Tribal Agency Position Supporting Materials

APPENDIX C – TRIBAL AGENCY POSITION SUPPORTING MATERIALS

Appendix C contains Tribal Cooperating Agencies' comments and supporting documentation that represent major differences of opinion with the analyses as presented in the SDEIS. The information was submitted by the Bois Forte, Grand Portage, Fond du Lac, Great Lakes Indian Fish & Wildlife Commission, and the 1854 Treaty Authority. All materials in this appendix are Tribal views provided verbatim and have not been validated or approved by the Co-lead Agencies.

Figure I-05-02.2

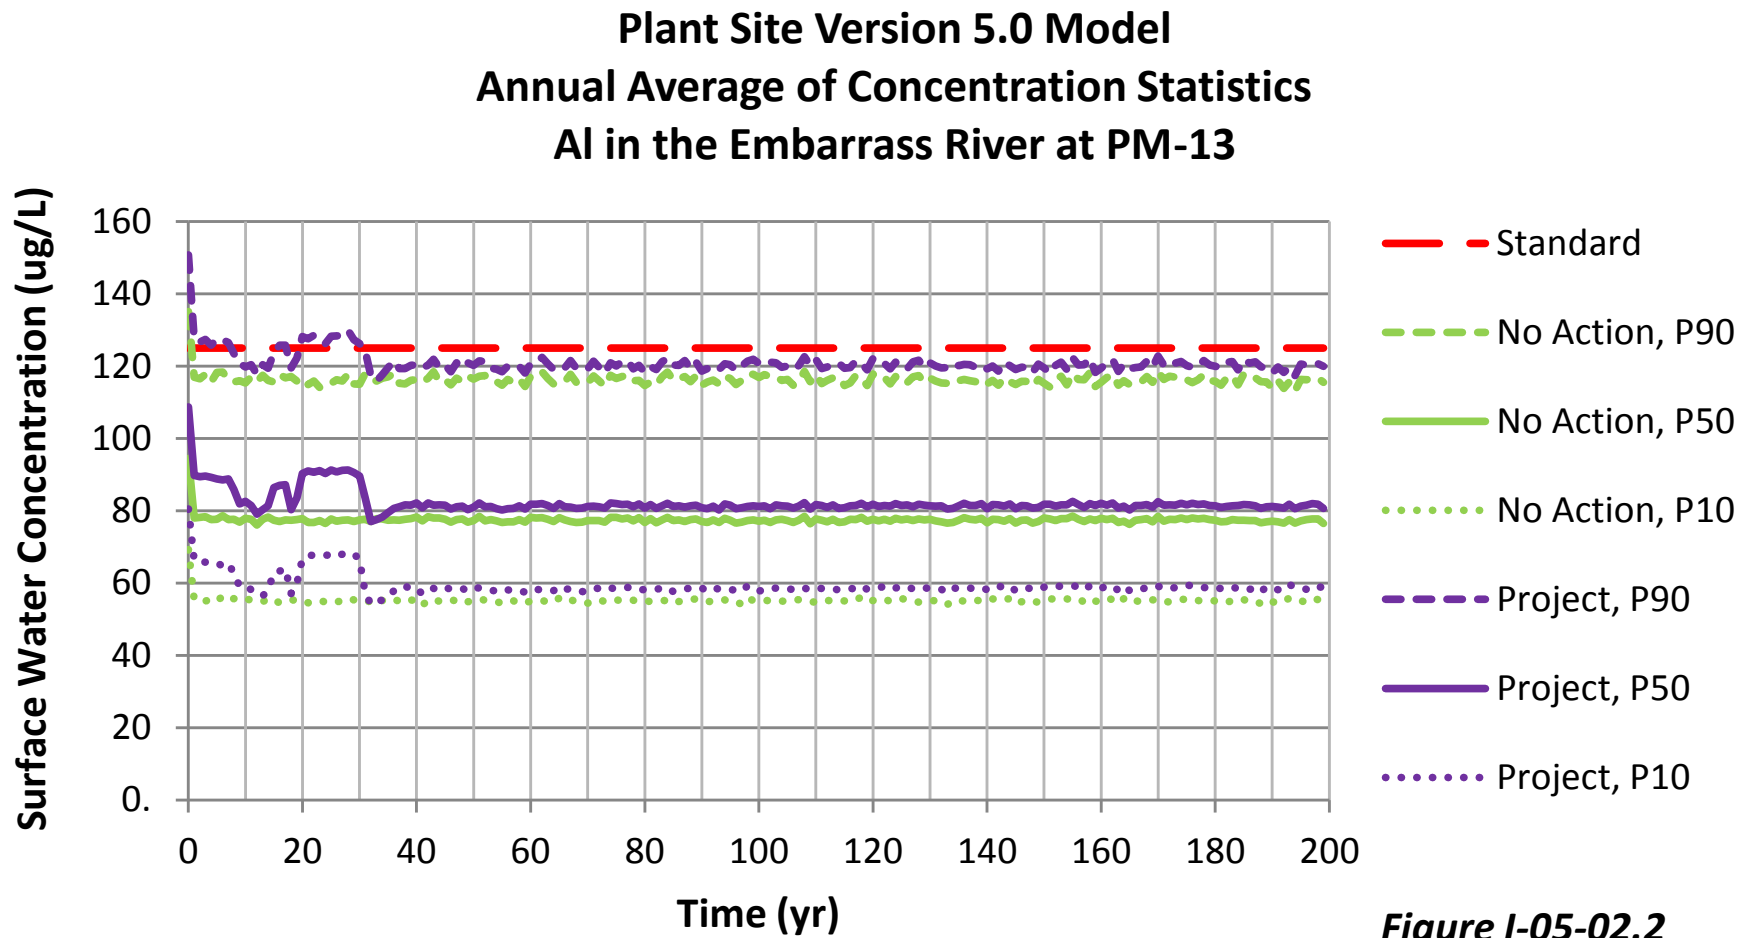
- - PSDEIS Table 4.2.2-29 shows that observed average Al at PM-13 is 221 ug/L. This observed average is much higher than the modeled No-Action (continuation of existing conditions) P50 annual maximum (PSDEIS Table 5.2.2-47, 159-166 ug/L). The modeled No-Action P50 annual average for Al at PM-13 of 75 ug/L (attached Fig.I-05-02.2, Water Modeling Data Package Vol 2-Plant Site v9 MAR2013) is only 1/3 of the observed average.

Figure F-01-10.1

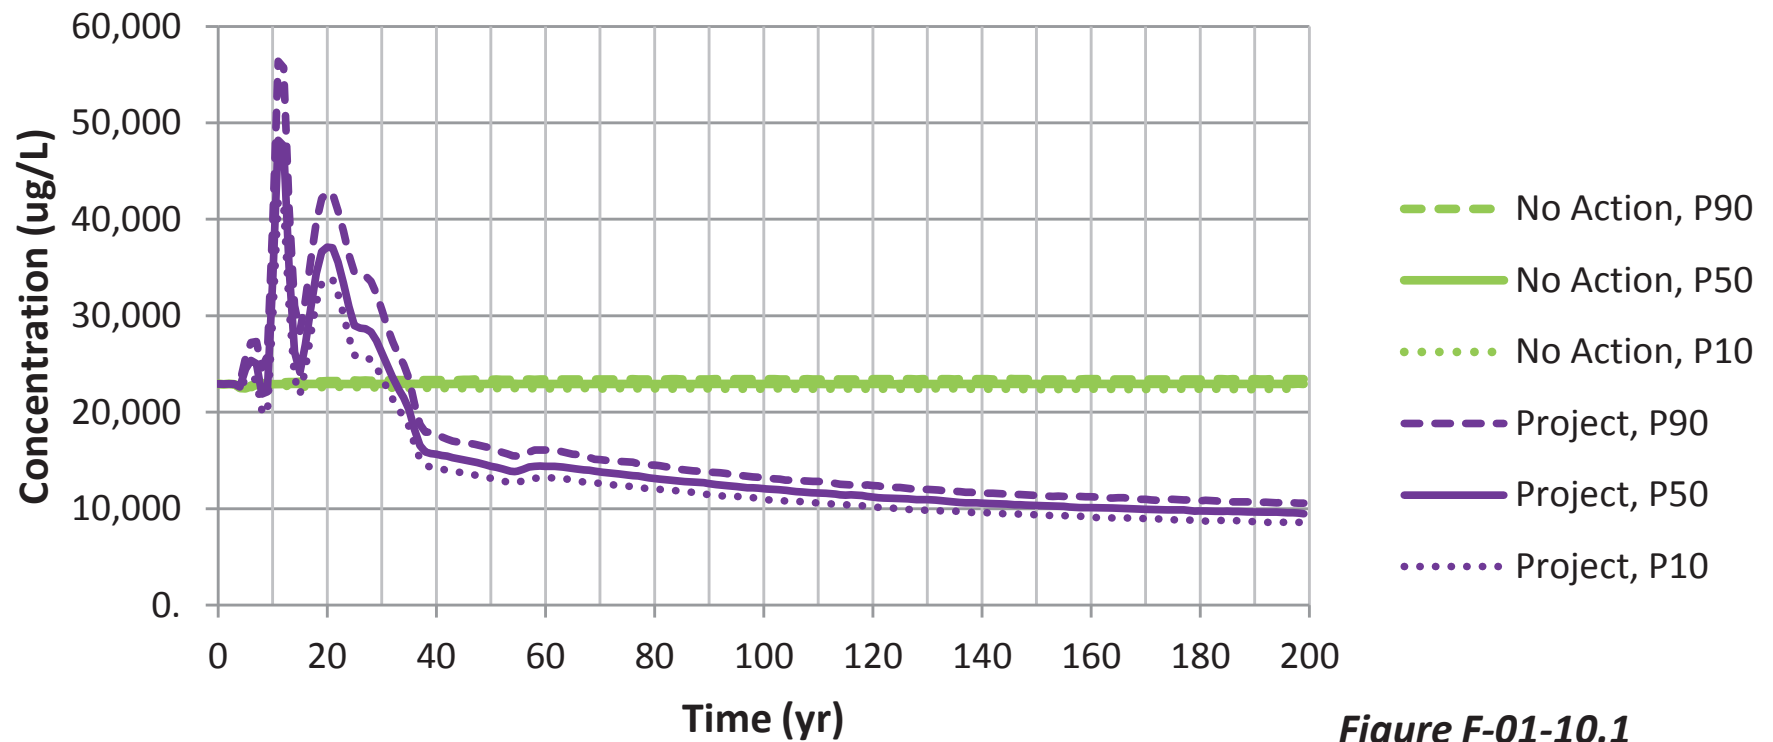
Based on the above CEQ guidelines, it is clear that activities that will occur under the Cliffs Consent Decree should be included in modeling of a No Action alternative. Unfortunately not only are the consent decree activities not included, but the fact that it will be precipitating on the tailings basins for the foreseeable future has not been included in the No Action modeling. This is evident by the model results that show stable levels of Chloride coming from the basins for the next 200 years (Figure attached) when there is no ongoing source for Chloride. With no source for new Chloride, rainwater will gradually dilute the residual Chloride in the basin and levels will drop. The PSDEIS claims that the basins water quality has stabilized and that the current conditions will not change over time. The claim of chemical stability is based on basin pond water sampling for only 4 years (2001 - 2004, PSDEIS Table 4.2.2-23).

Figure 4. Mean specific conductance measurements at monitoring stations downstream of mine point discharges were inversely related to distance downstream from mine point discharge sites.

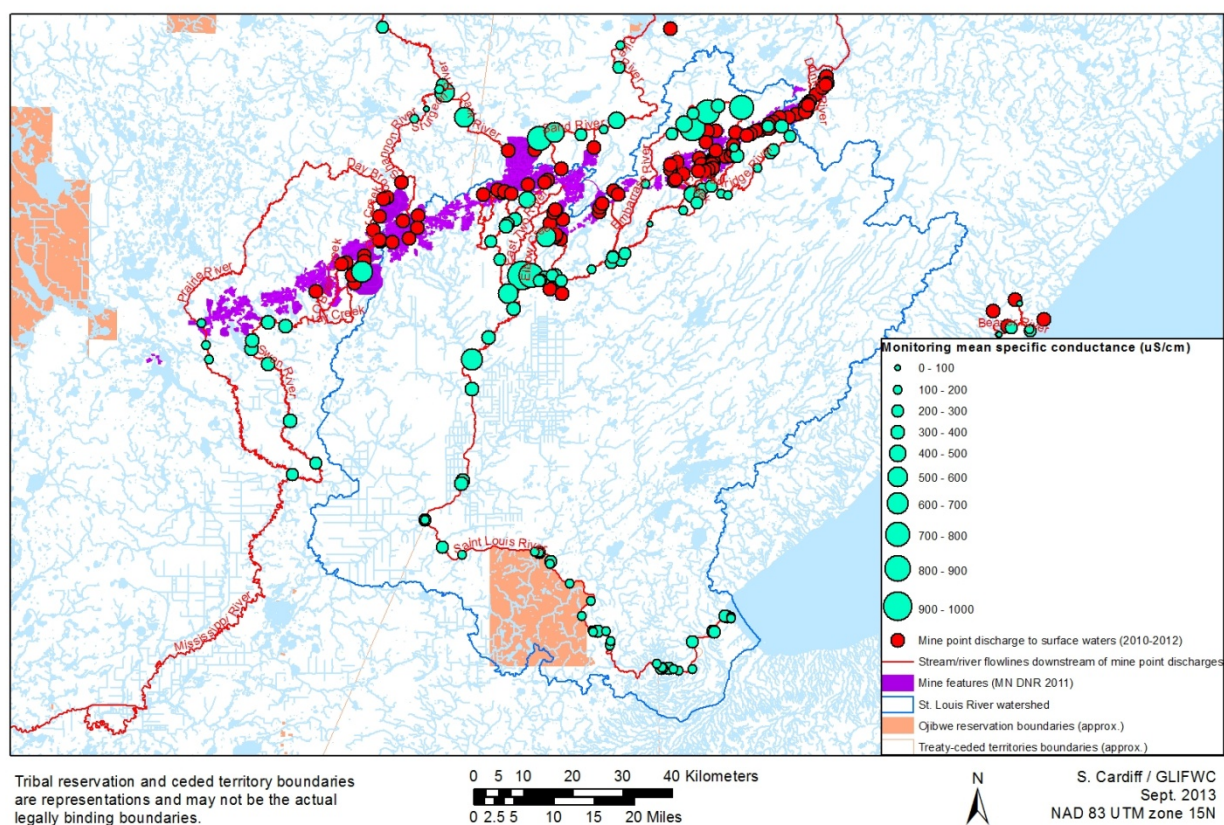
Tribal staff conducted analysis of specific conductance downstream of mine discharges using agency monitoring data (1990-2013). Analysis of specific conductance downstream of mine discharge sites indicated that specific conductance was highest nearest to mine discharge sites, and tended to only gradually decrease downstream of mine discharge sites. Linear regressions demonstrated that specific conductance was significantly negatively related to distance across all sample sites ($P < 0.01$, $R^2 = 0.15$; $n = 123$ sites; Fig. 4) and within the St. Louis River and Swan River systems ($P < 0.05$, $R^2 = 0.18$ and 0.52 , respectively; Fig. 5). This analysis included stream and river monitoring only (not lakes). The regression suggests that specific conductance could drop to 150 $\mu\text{S}/\text{cm}$ only 203 km (126 mi) downstream of the nearest upstream mine discharge site.

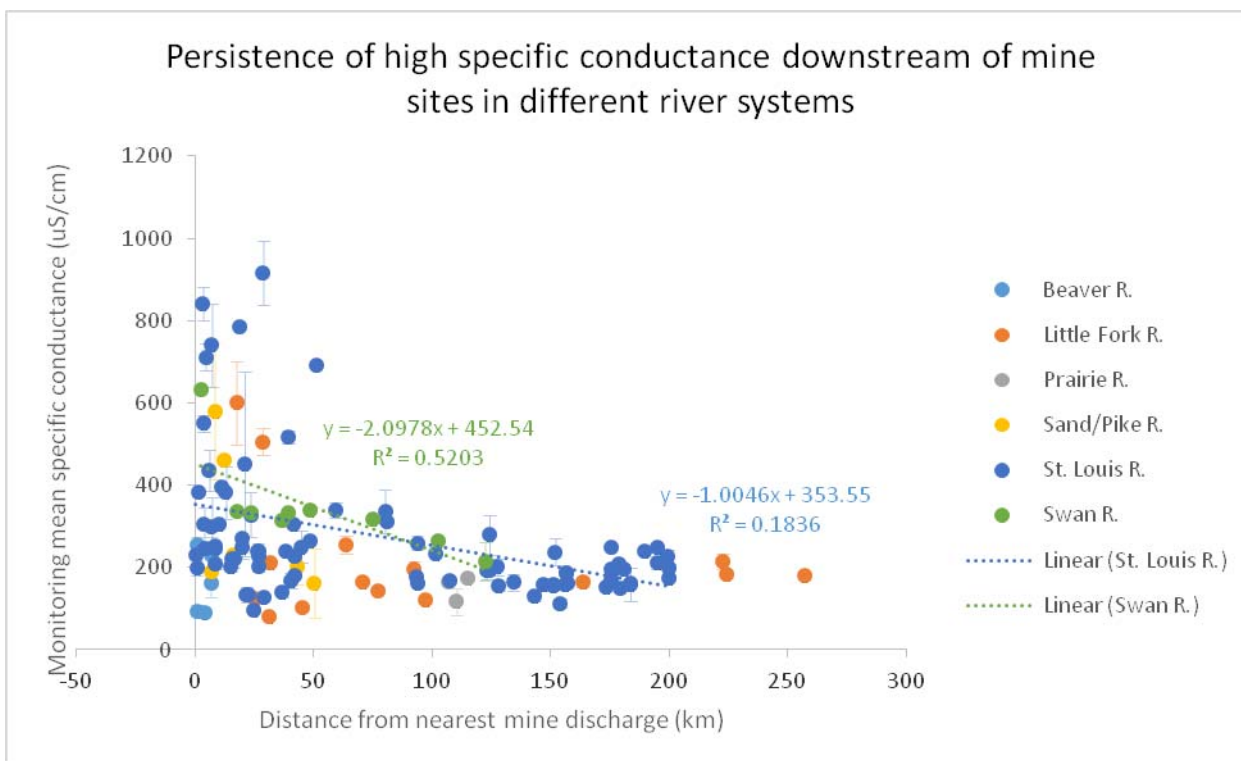
These analyses demonstrate that existing mining discharges result in elevated concentrations of pollutants that persist far downstream in the St. Louis River, which is consistent with the findings of the USEPA in their assessment report on the effects of mountaintop removal and valley fill mining².

Figure 14. Mean sulfate concentrations at monitoring stations downstream of mine point discharges was inversely related to distance downstream from the discharge sites.

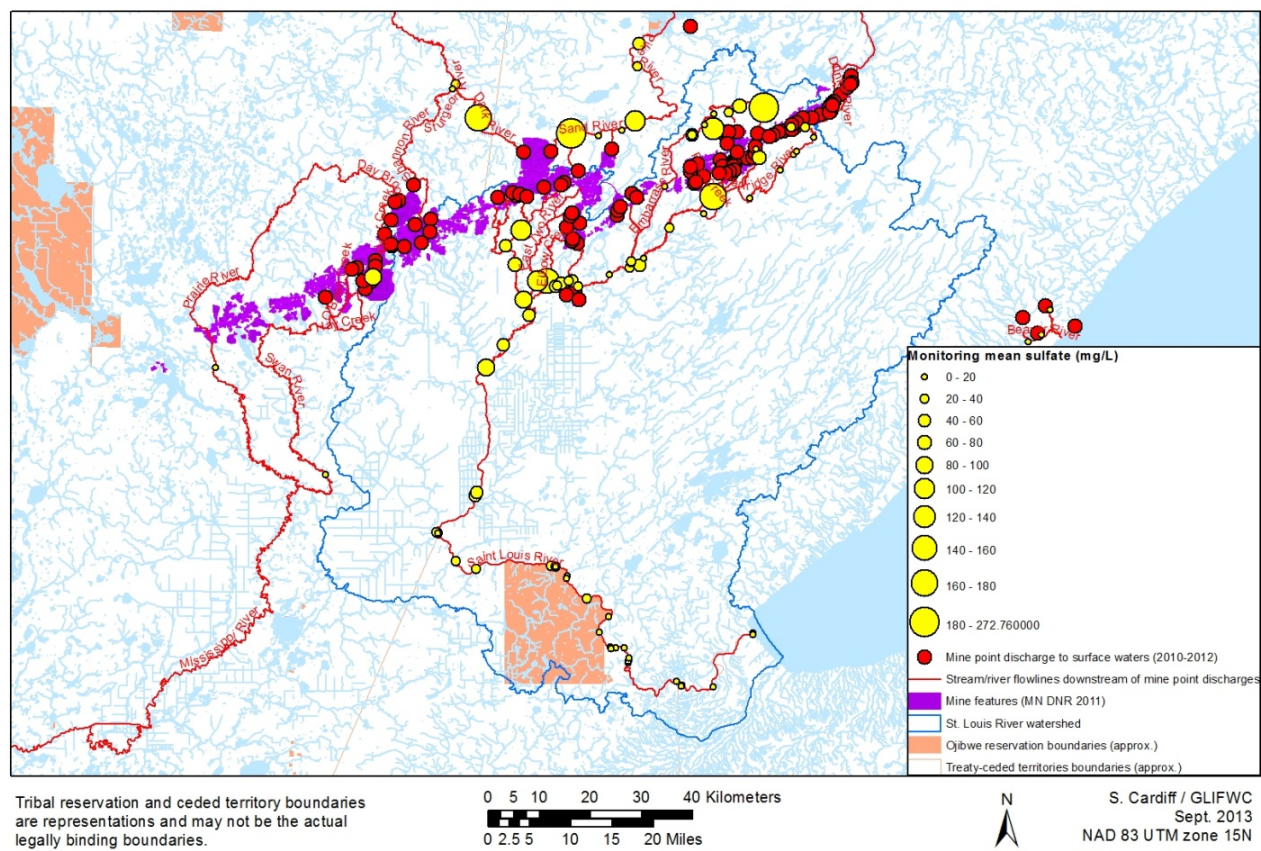
Tribal staff did additional analysis of sulfate concentrations throughout the St. Louis River watershed. Analysis of sulfate concentrations downstream of mine discharge sites indicated that sulfate concentrations were highest nearest to mine discharge sites, and tended to only gradually decrease downstream of mine discharge sites. Linear regressions demonstrated that mean sulfate was significantly negatively related to distance across all sample sites ($P < 0.01$, $R^2 = 0.14$, $n = 92$) and within the Saint Louis River system ($P < 0.01$, $R^2 = 0.17$, $n = 73$; Figure 14). This analysis included stream and river monitoring only (not lakes).

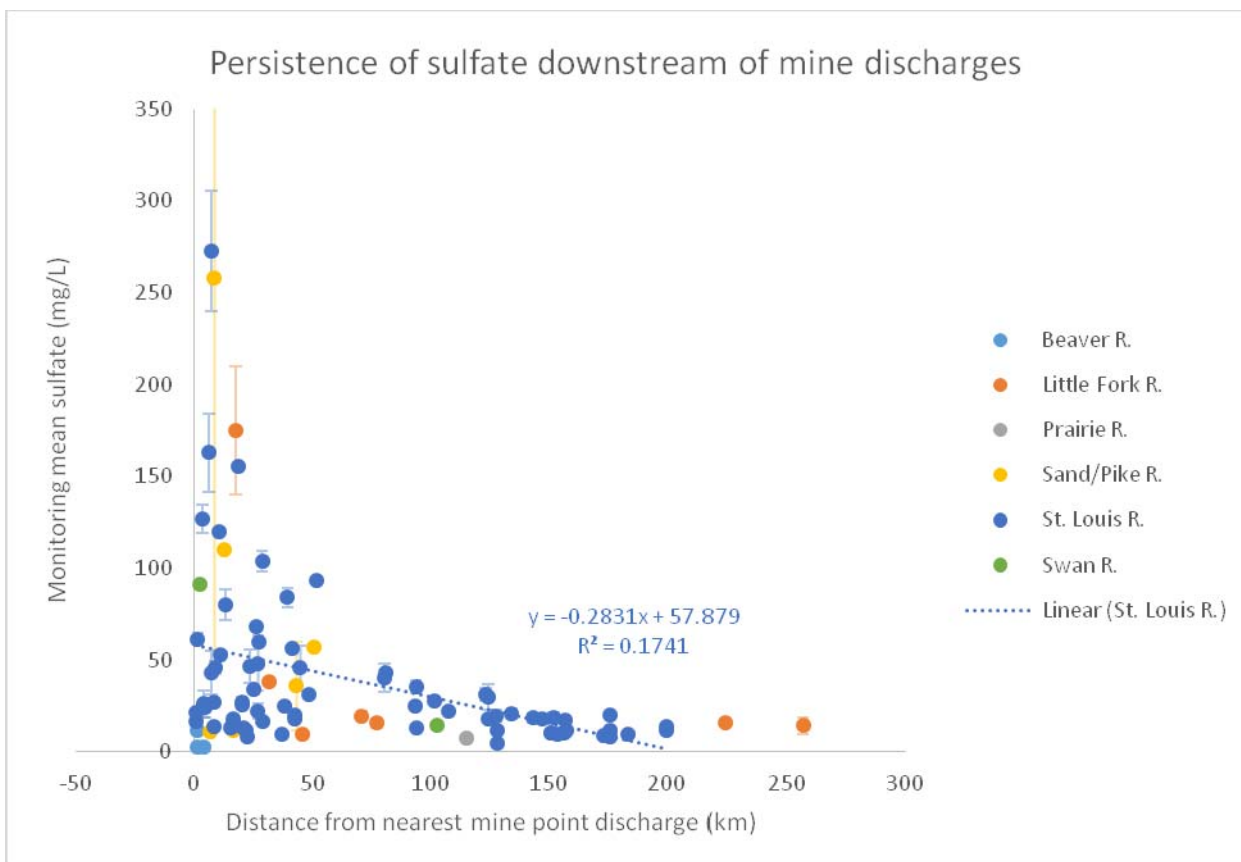
The regression suggests that sulfate concentrations could drop to less than 10 mg/L only 170 km (105 mi) downstream of the nearest upstream mine discharge site (Figure 15).

Figure 21. Combined Noise, Airblast and Ground Vibration Impact Area for Wildlife

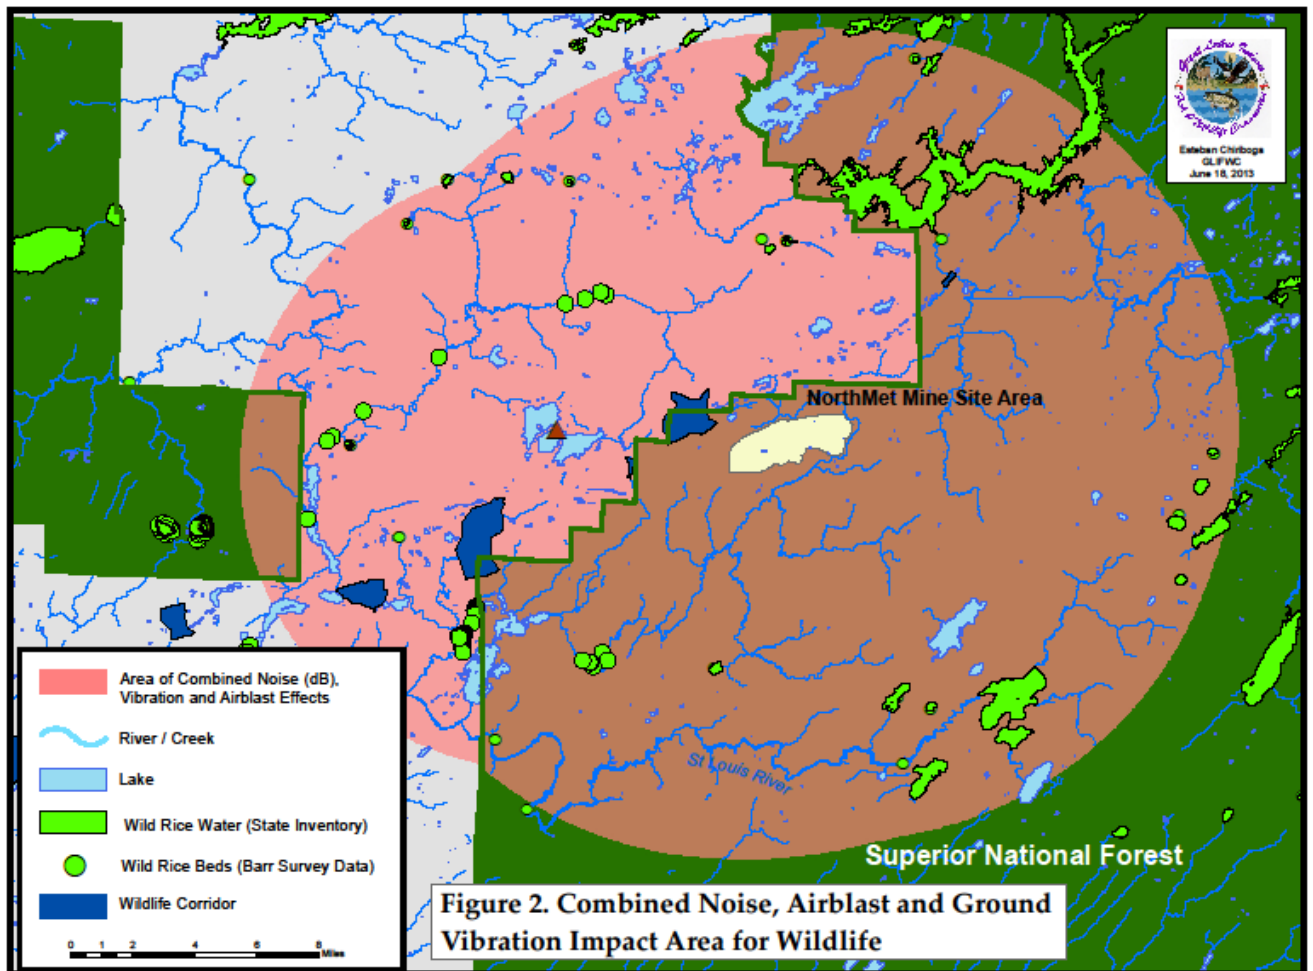
Figure 21 indicates the noise area of impact for wildlife. The noise contours are unweighted decibel values (dB). A more complete analysis of these impacts in the SDEIS document for the NorthMet project is needed. Known locations of wild rice are included in the map because it is an important source of food for waterfowl. We also note that the entire area of impact is important habitat for Canada Lynx.

As illustrated in Figures 21 and 22, the impacts of noise, airblast and ground vibration overlap in a large area surrounding the mine site. Figure 21 (Cumulative Impacts on Wildlife) also provides the location of the remaining wildlife corridors in the area. The wildlife corridor immediately northwest of the mine site would be cumulatively affected by noise (10dBL and 50 dBL) airblast overpressure and ground vibration. These impacts when thought of in the context of its proximity to the mine site, wetland destruction and fragmentation of the 100 mile swamp lead to a conclusion of a severe and significant impact to this corridor. Figure 22 (Cumulative Impacts on Humans) indicates areas of tribal significance that are affected.

Figure 23. Annual Maximum of Concentration Statistics: Chloride at the North Toe.

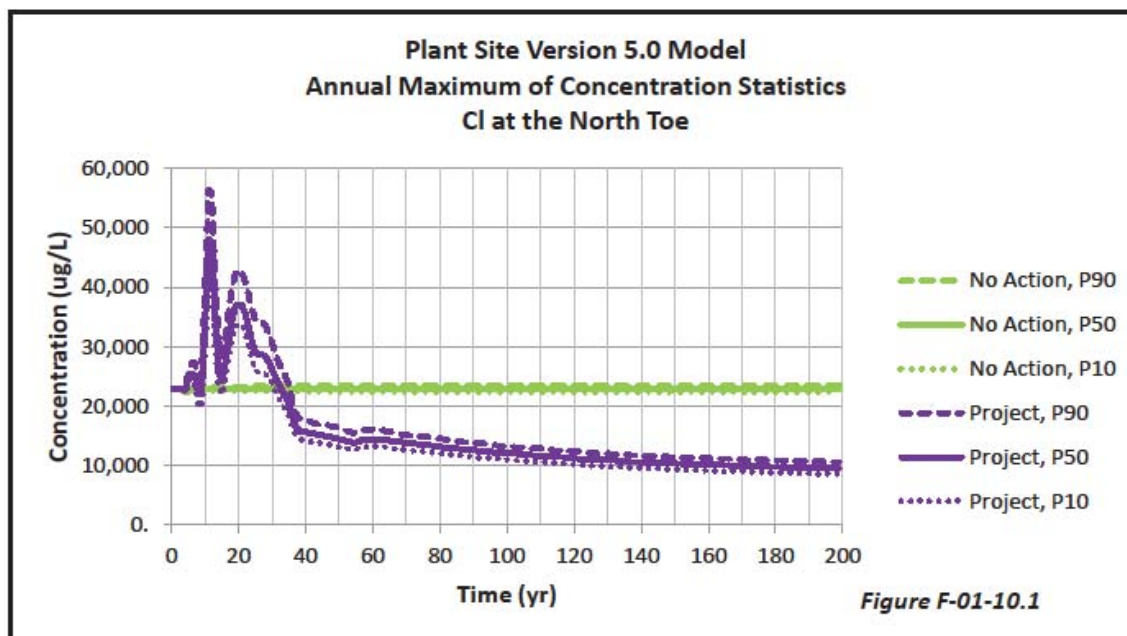
Based on the above CEQ guidelines, it is clear that activities that will occur under the Cliffs Consent Decree should be included in modeling of a No Action alternative. Unfortunately not only are the consent decree activities not included, but the fact that it will be precipitating on the tailings basin for the foreseeable future has not been included in the No Action modeling. This is evident by the model results that show stable levels of chloride coming from the basin for the next 200 years (Figure 23) when there is no ongoing source for chloride. With no source for new chloride, rainwater will gradually dilute the residual chloride in the basin and levels will drop. The PSDEIS claims that the basin's water quality has stabilized and that the current conditions will not change over time. The claim of chemical stability is based on basin pond water sampling for only 4 years (2001 – 2004, PSDEIS Table 4.2.2-23).

Since there has been no water quality data collected in the basin pond for 9 years it is reasonable to assume that the past 9 years of precipitation has diluted the water chemistry in the basin pond, and that eventually the more dilute water will percolate through the basins and be discharged at the toe. If chemical stability is to be assumed, more recent data on basin pool water chemistry is needed. While the CEQ makes it clear that a blind "continuation of existing conditions" model is inappropriate as a No Action alternative, a "continuation of existing conditions" model that ignores simple environmental processes such as precipitation is even less appropriate.
